File 1981-0050

Project Name: The Grand Hotel and Office – Development in H.O.

Final Development Plan

Figure 1  
**Distribution of Generated Traffic**  
 Percent of Approaching and Departing Traffic

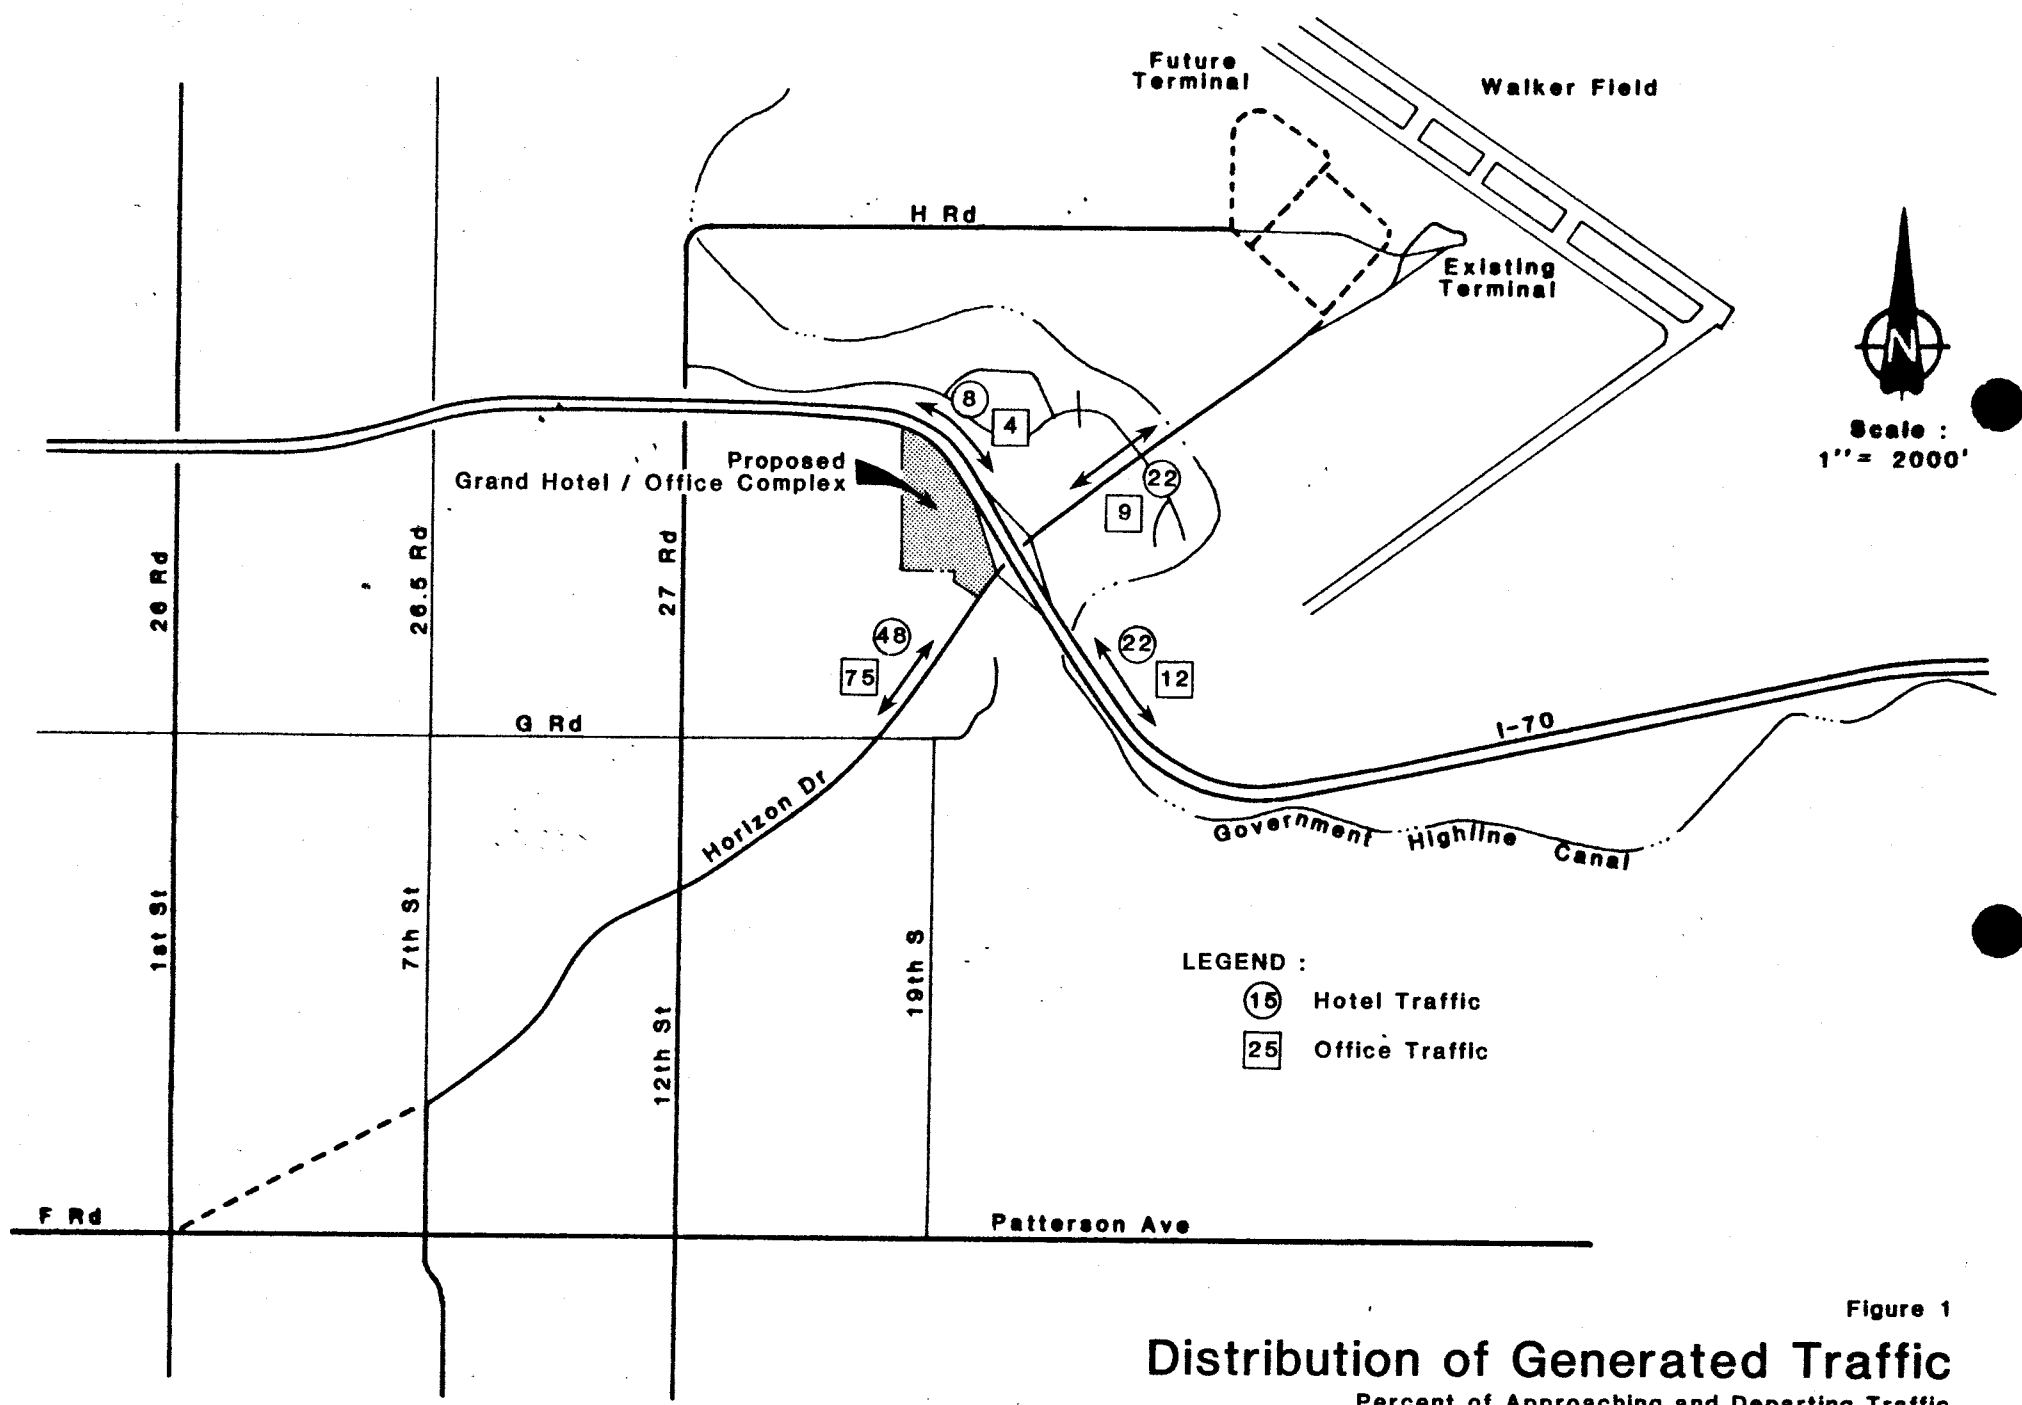
Figure 1 illustrates the estimated distribution patterns of the traffic generated by the proposed Grand Hotel/Office Complex. As indicated, slightly different traffic distributions can be expected for the hotel and office generated trips. The majority of the hotel generated traffic will be to and from Walker Field and I-70 while the majority of the traffic generated by the office complex will be to and from the major residential areas in and around Grand Junction. As indicated, about 75 percent of the office complex traffic and 48 percent of the hotel traffic will travel Horizon Drive between I-70 and G Road. About 12 percent of the office traffic and 22 percent of the hotel traffic are anticipated to travel I-70 to and from the east.

Figure 2  
**Average Weekday Traffic**  
Generated by Grand Hotel / Office Complex

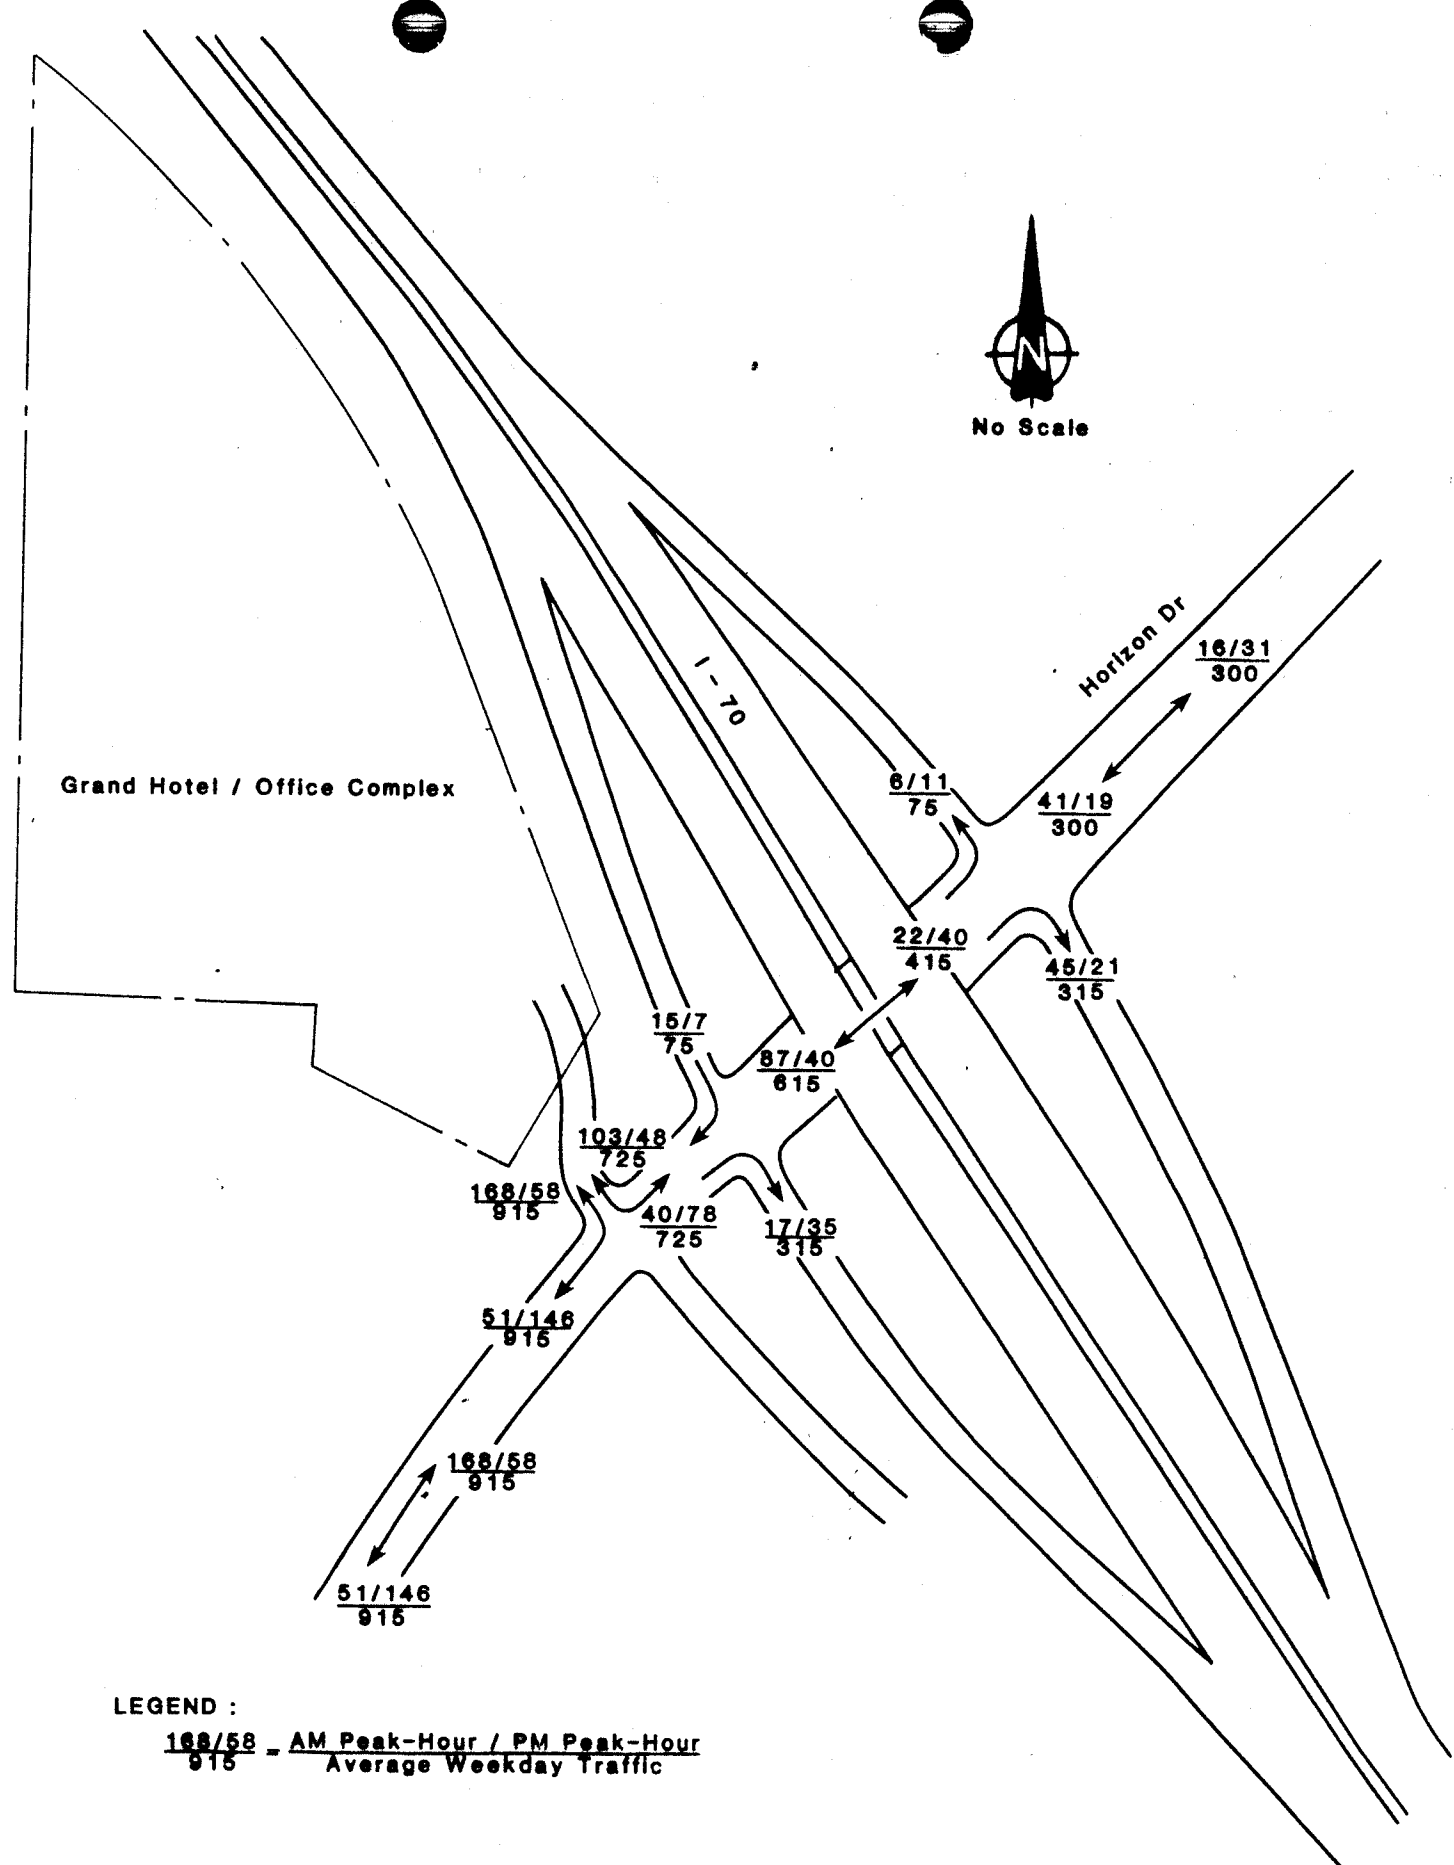
Based on the distribution patterns of Figure 1 and the estimated number of average weekday generated trips from Table 1, the daily traffic volumes on the surrounding roadway system have been estimated. Figure 2 illustrates the average weekday and morning and evening traffic volumes anticipated to be generated by the Grand Hotel/Office Complex at full development. About 1,830 vehicles per day will travel Horizon Drive south of the site while about 600 vehicles per day will travel Horizon north of I-70.

# Recommended Horizon Dr Channelization

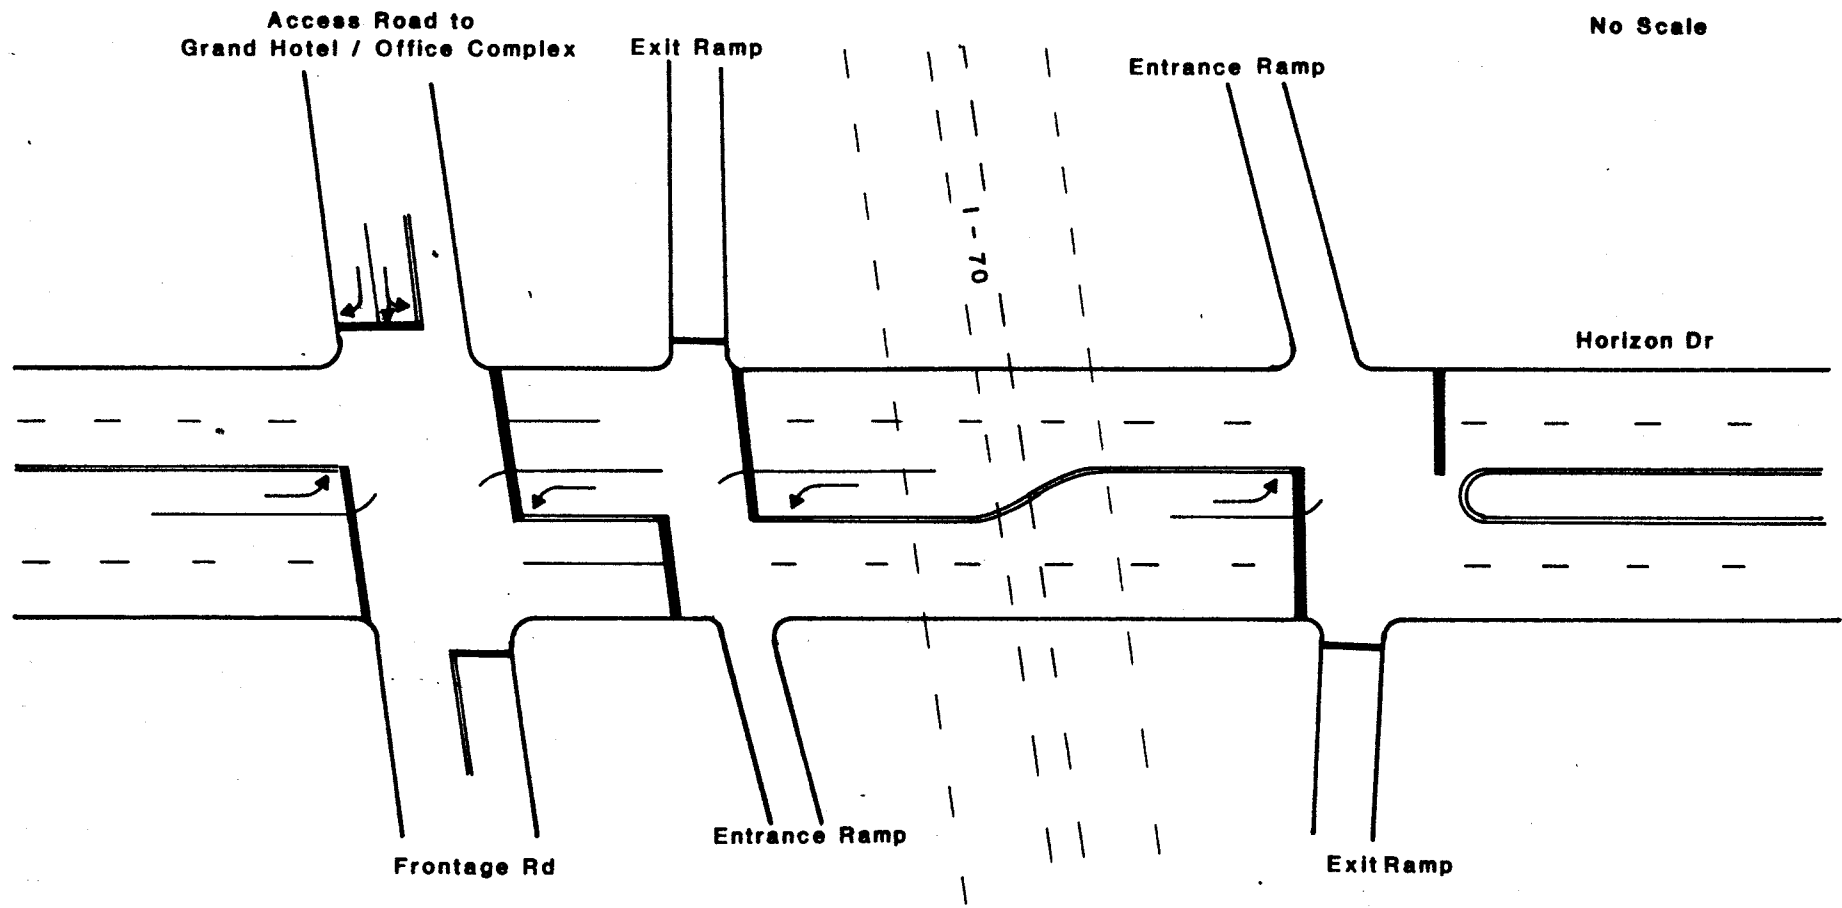
3. The channelization of Horizon Drive should incorporate a continuous left-turn lane for southbound Horizon Drive traffic at the eastbound I-70 entrance ramp and adjacent frontage road intersections, as shown on Figure 3.
